**CITY OF FORT COLLINS
TYPE 1 ADMINISTRATIVE HEARING
FINDINGS AND DECISION**

PROJECT NAME: Centre for Advanced Technology 23rd Lot 2 Office Building

CASE NUMBER: FDP150007

SHEET TITLE
Landscape Plan

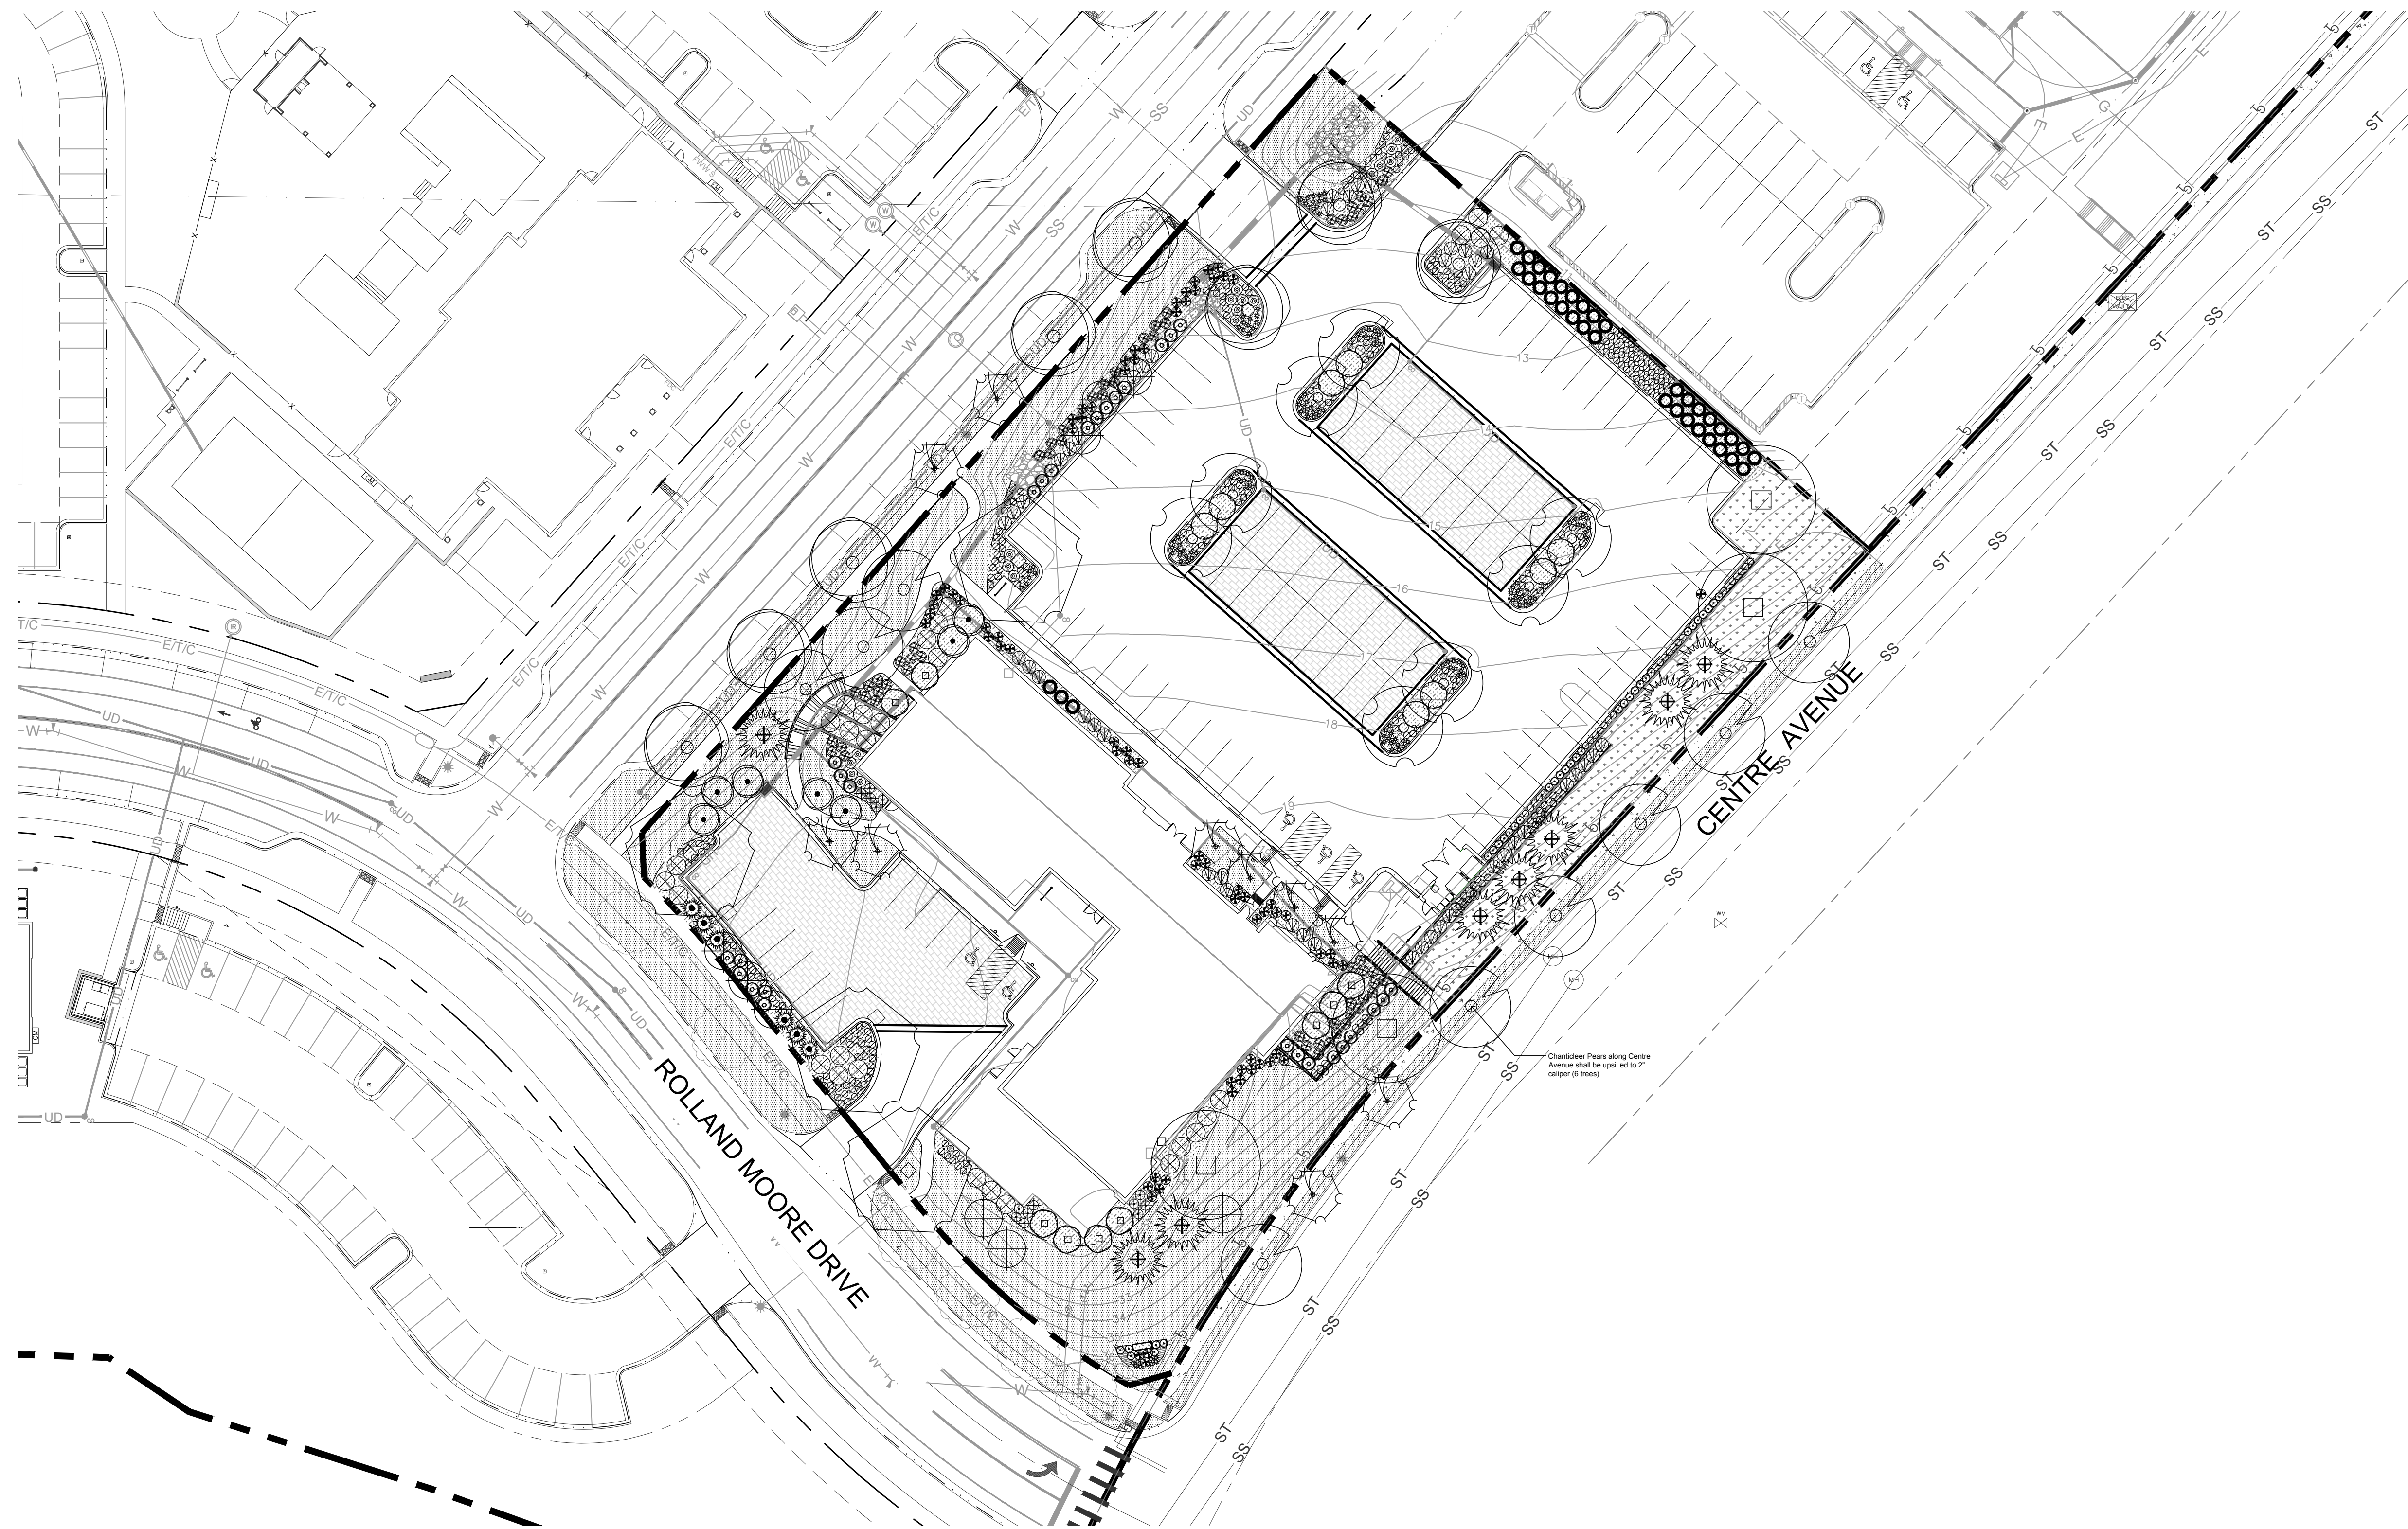
The proposed landscaping meets the minimum tree stocking standards. The proposed landscape plan shows groups of canopy, coniferous evergreen, and ornamental trees planted in closer proximity than the minimum requirements outlined in the code.

The Land Use Code requires canopy shade trees to be planted at thirty to forty-foot spacing in the center of parkway areas where the sidewalk is detached from the street. The proposed trees are upsized Chanticleer Pear, which is an ornamental tree. This tree type is consistent with the street trees on Centre Avenue that were installed with the development of Lot 1 of the Centre for Advanced Technology 23rd filing. Upsized Chanticleer Pear trees were used since the narrow parkway along Centre Avenue cannot support canopy trees. Due to the width limitation of the parkway, the proposed development meets this code requirement by staying consistent with the street tree planting standards applied to adjacent developments.

1 SOUTH ELEVATION
1/8" = 1'-0"

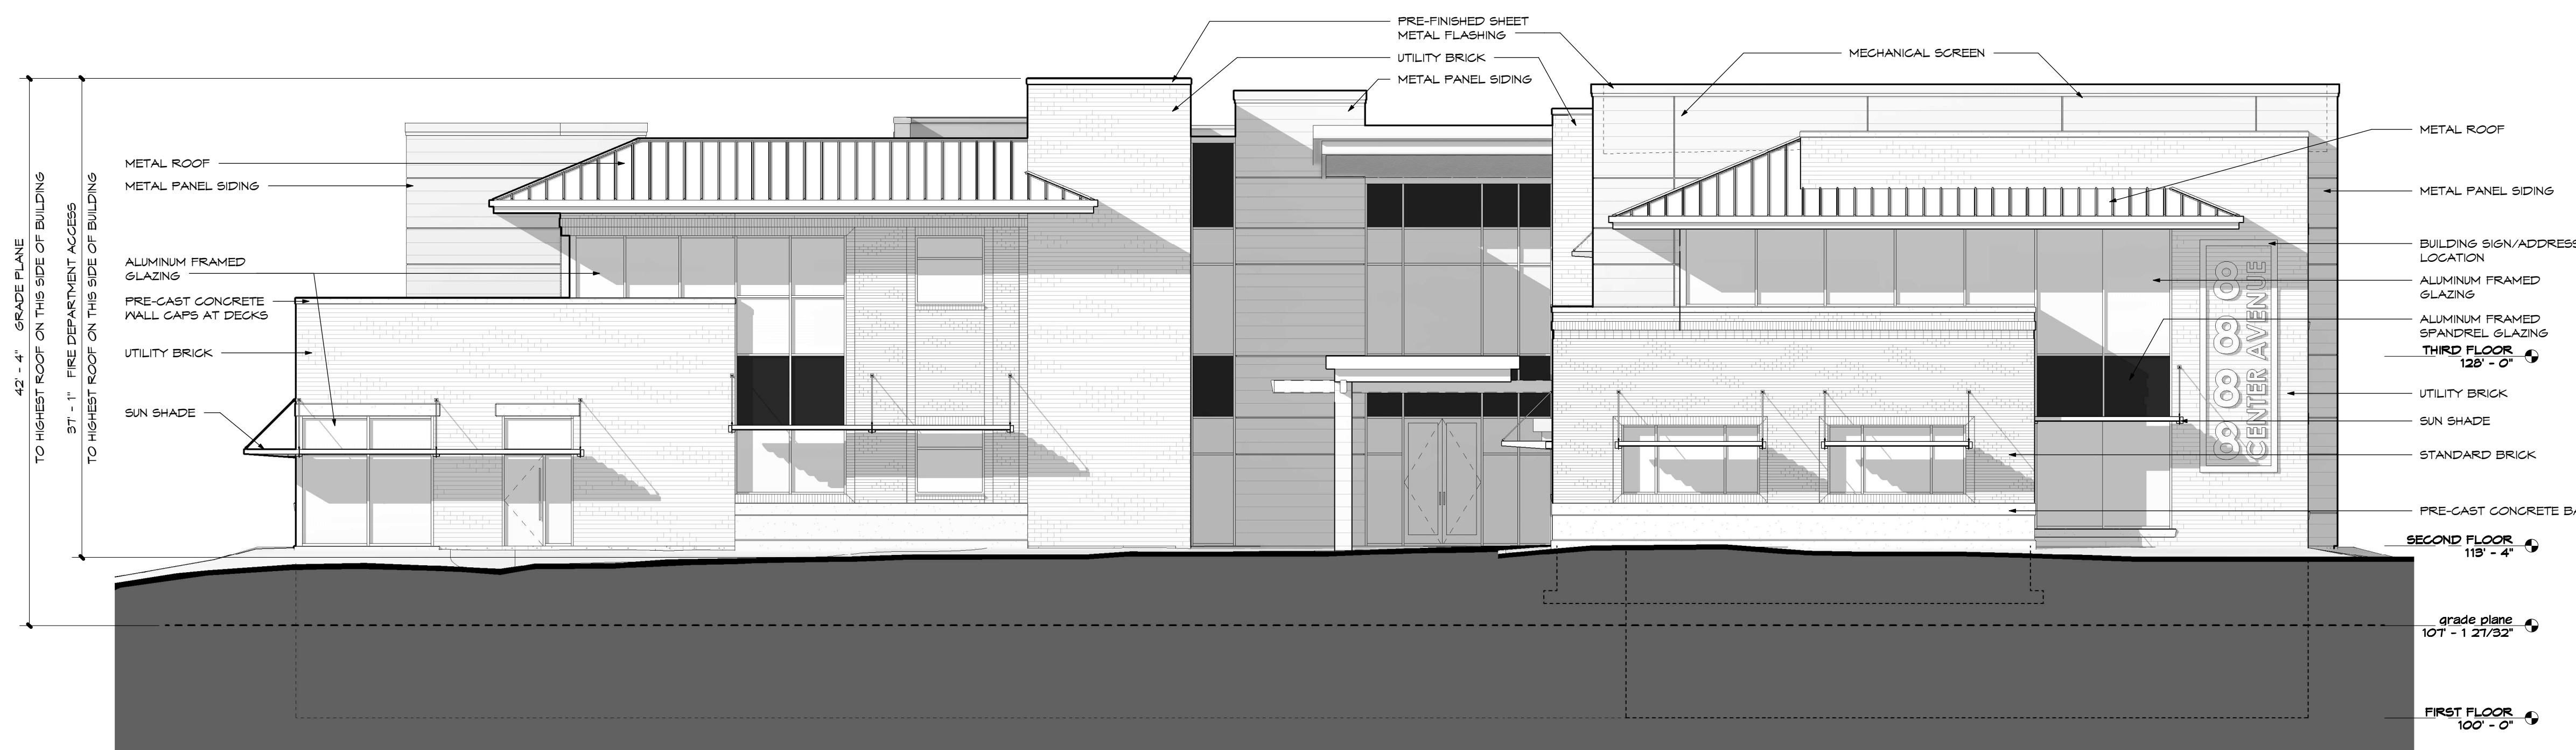
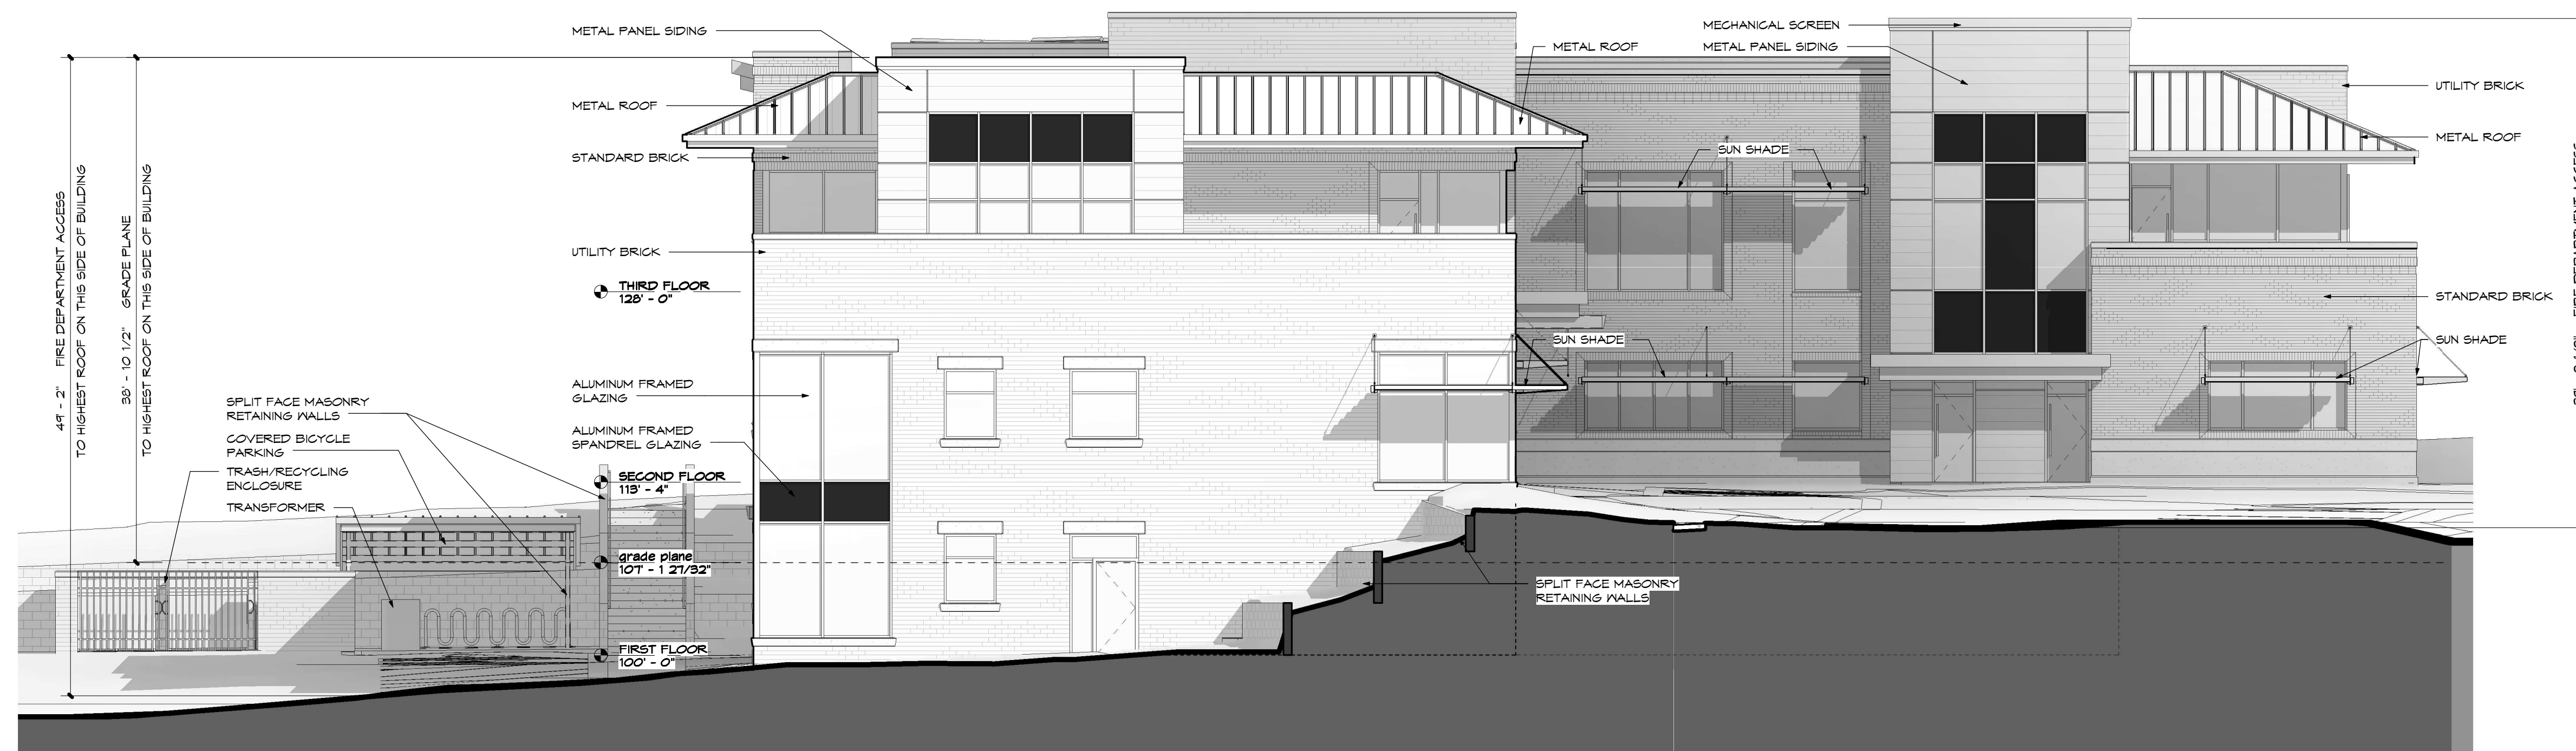
The proposed building is consistent with the requirements of the Land Use Code in regards to horizontal massing and changes in massing being related to entrances, the integral structure and interior spaces of the building. No horizontal plane exceeds a 1:3 height-width ratio. The changes in massing also relate to building features such as doors and windows, which are integral to the interior spaces of the building.

The proposed building is consistent with the relevant requirements of this Land Use Code section including façade treatments, entrances, and base and top treatments. All walls break up their mass with windows, change in materials and fenestration pattern to provide a human scale. Each entrance to the building is clearly defined by awnings and recession from abutting sections of the building. Extruded bays with a cornice line and window shades on the first story define a clear base of the building. Sloped roofs, a cornice line and awnings define a clear top of the building.
